Levy Nuclear Plant, Units 1 & 2

COL Application

Technical Specifications

Section A. PSTS and Bases Differences from the DCD GTS and Bases (LNP COL 16.1-1)

FIGURE 4.1-1 Low Population Zone and Site Boundary Map

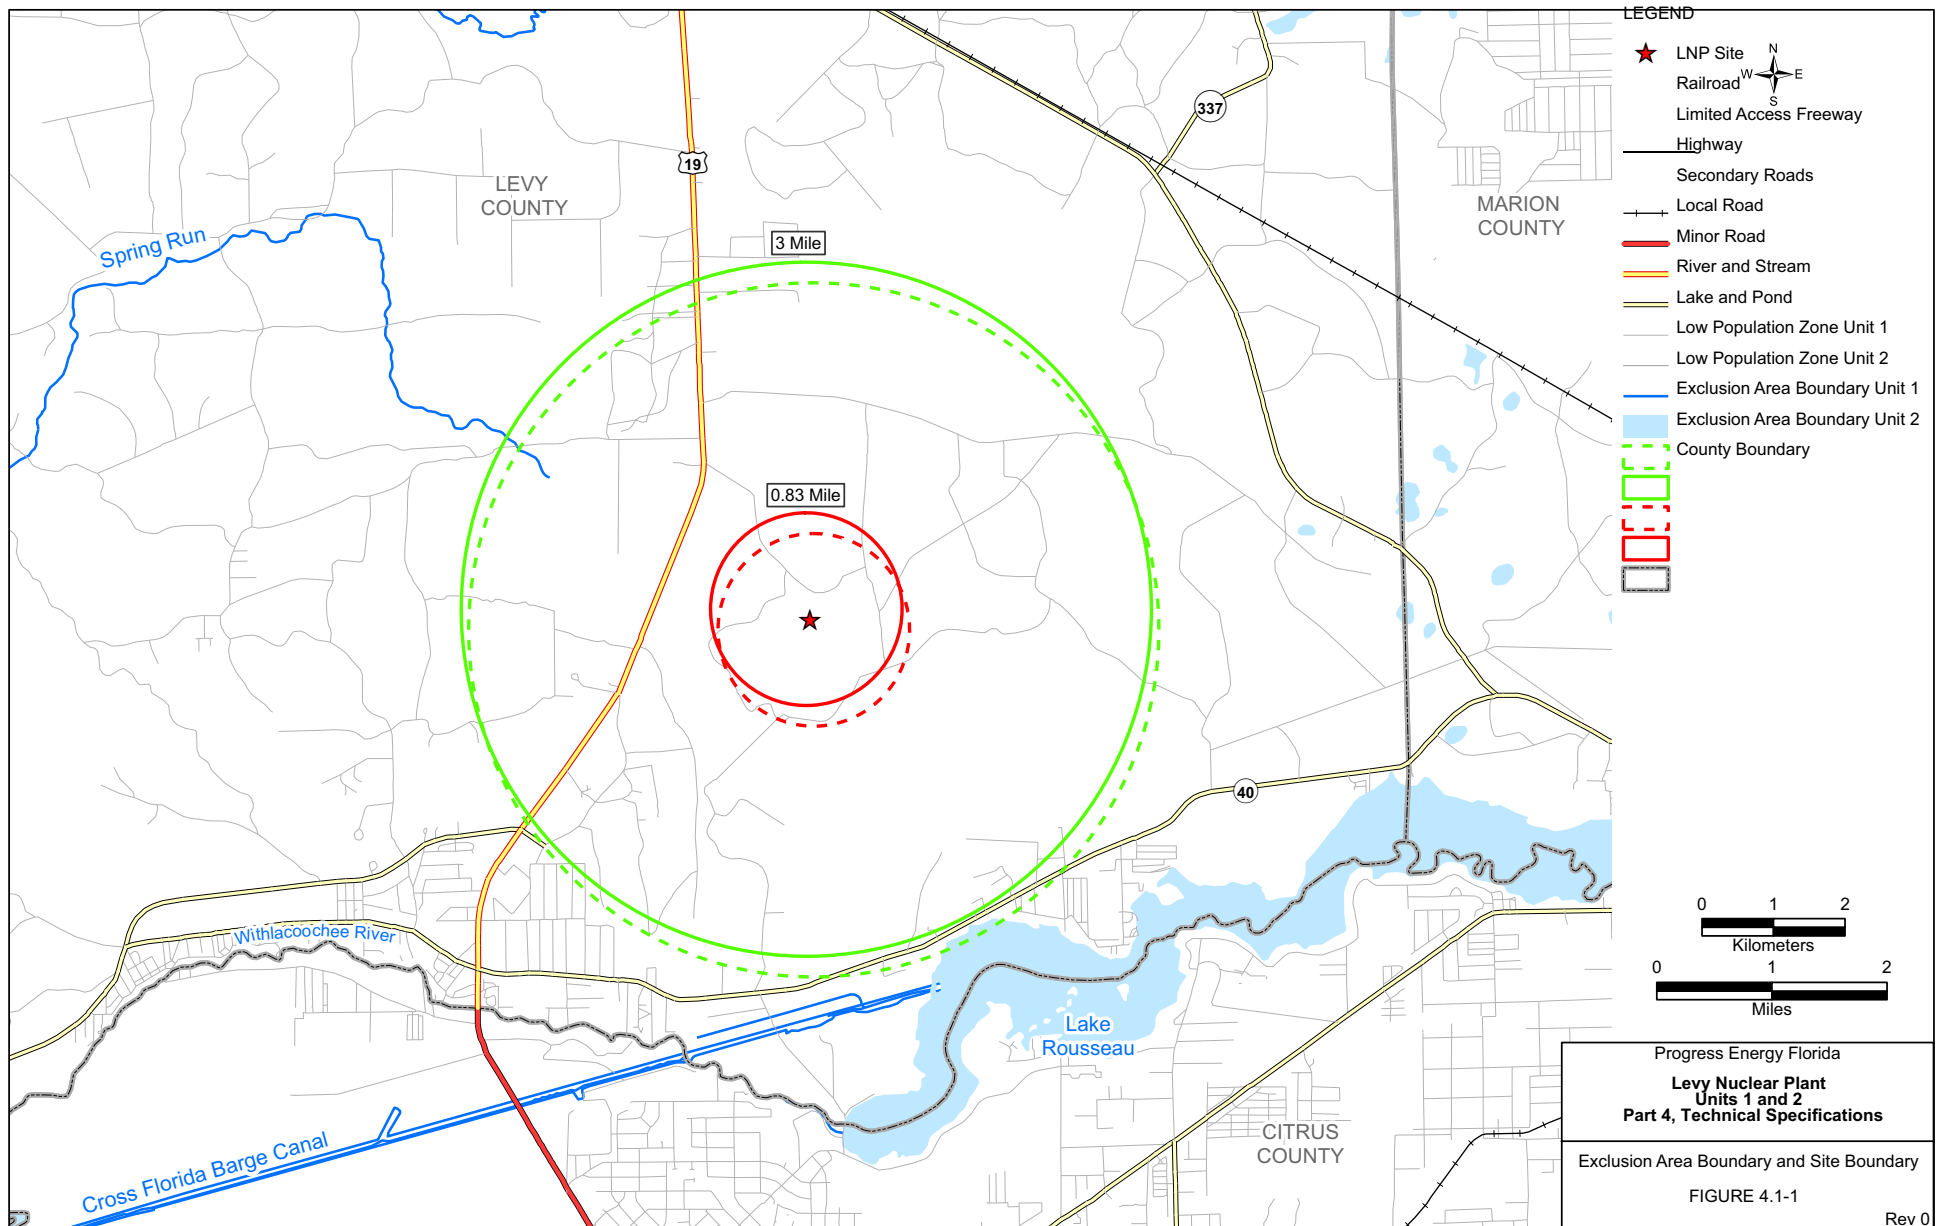
Replace the bracketed information in the GTS with the following:

The Site Boundary is shown in [Figure 4.1-1](#).

- GTS 4.1.2 The bracketed information in the GTS reads:
[This information will be provided by the combined license applicant.]
- Replace the bracketed information in the GTS with the following:
The LPZ is defined by the 3 mile radius from the site center point as shown in **Figure 4.1-1**.

FIGURE 4.1-2 Exclusion Area Boundary

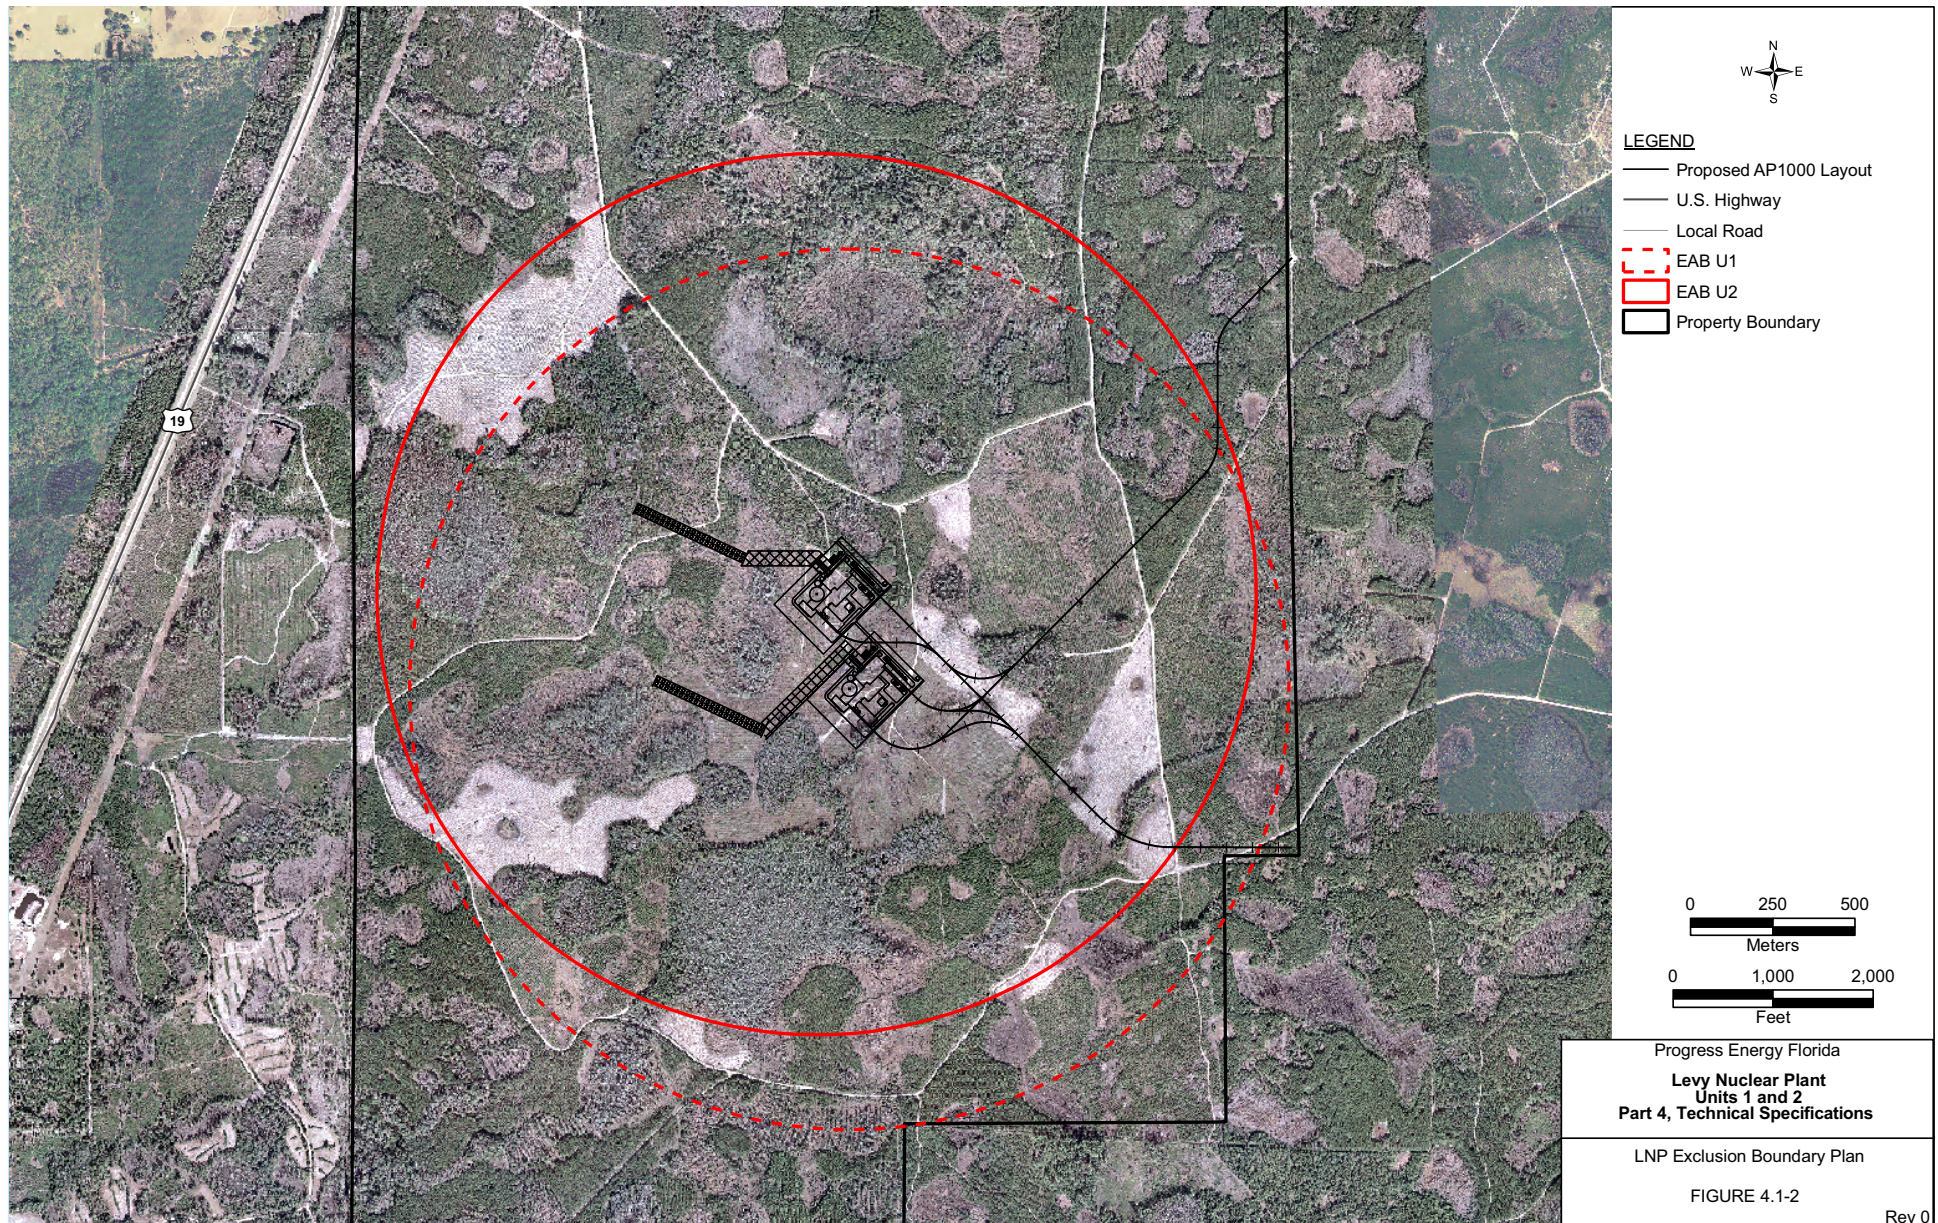
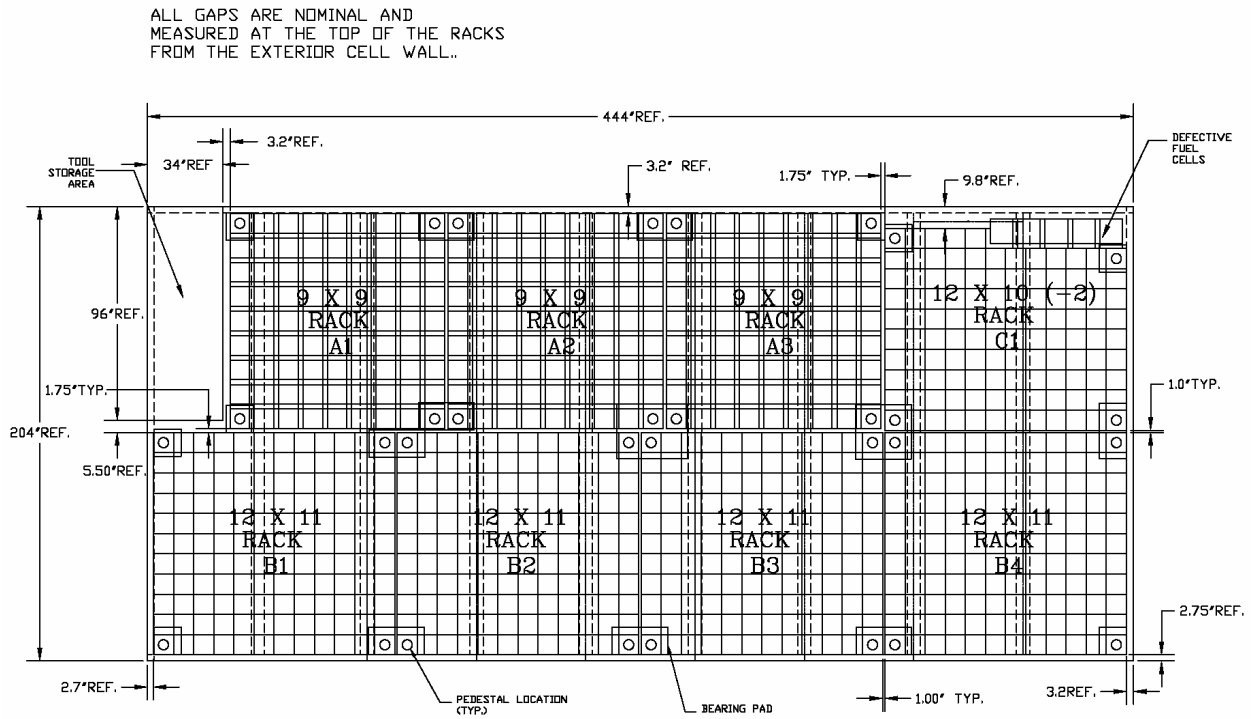
The Exclusion Area Boundary is shown in [Figure 4.1-2](#).

Figure B 3.6.8-1 (page 1 of 1)
Time Prior to Coolant Inventory Boiling

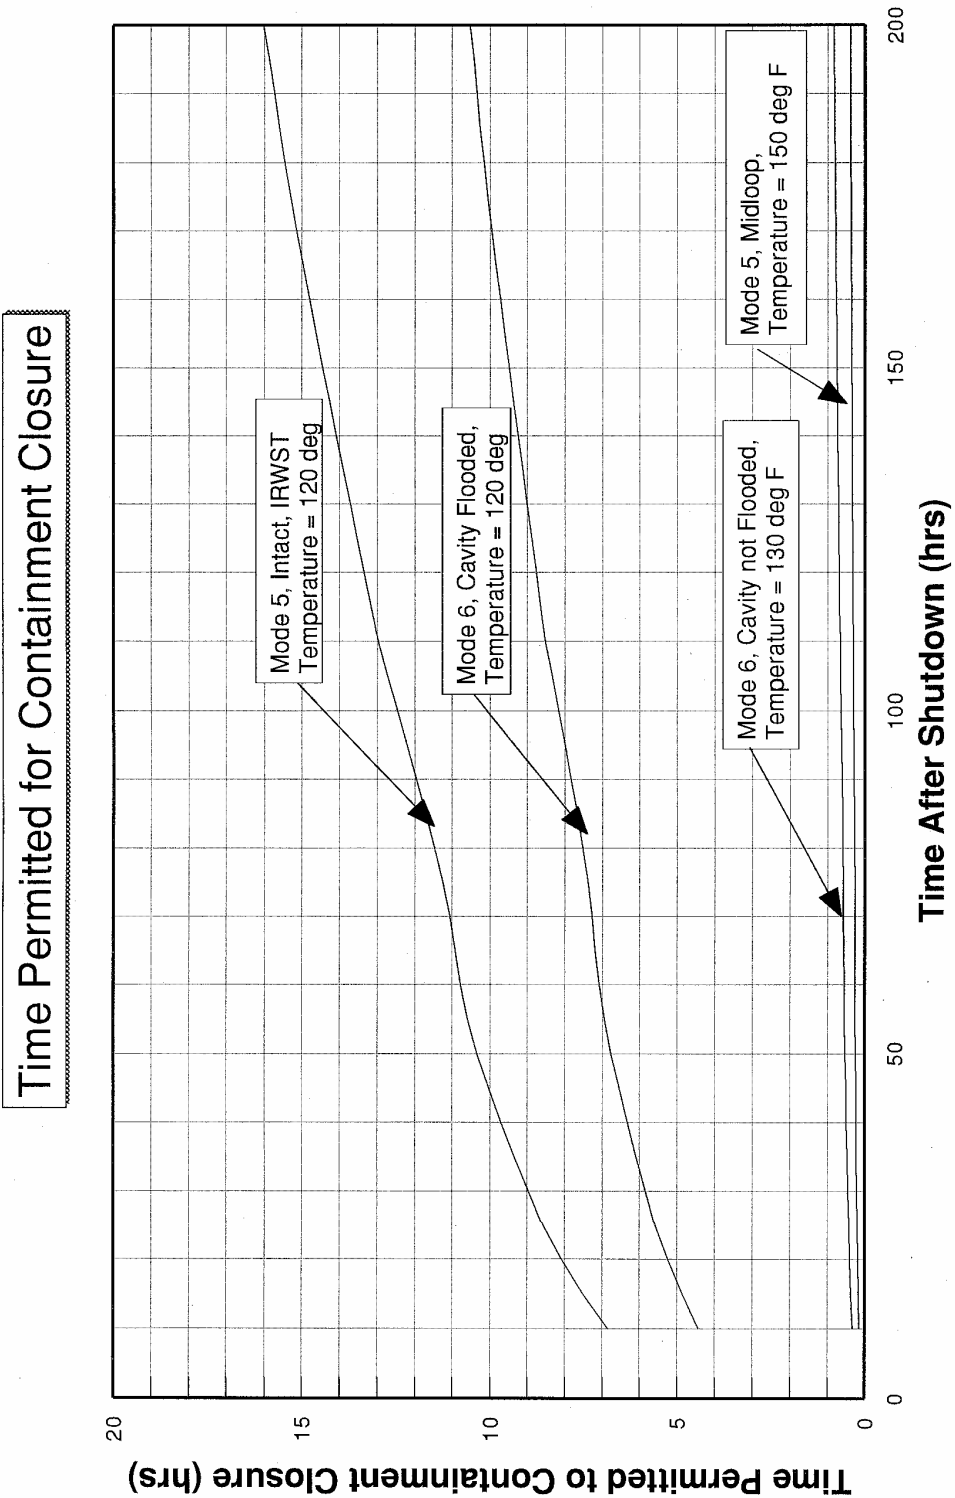
- GTS 3.6.8 Bases Figure B3.6.8-1 contains a bracketed curve identifying the time permitted for containment closure in terms of time after shutdown. The entire figure is bracketed. The plant specific curve needed to replace the bracketed value is determined from final fuel data. Therefore, a Bases change is required to provide a plant specific set of curves to replace the bracketed figure. This Bases change will be completed prior to initial fuel load.
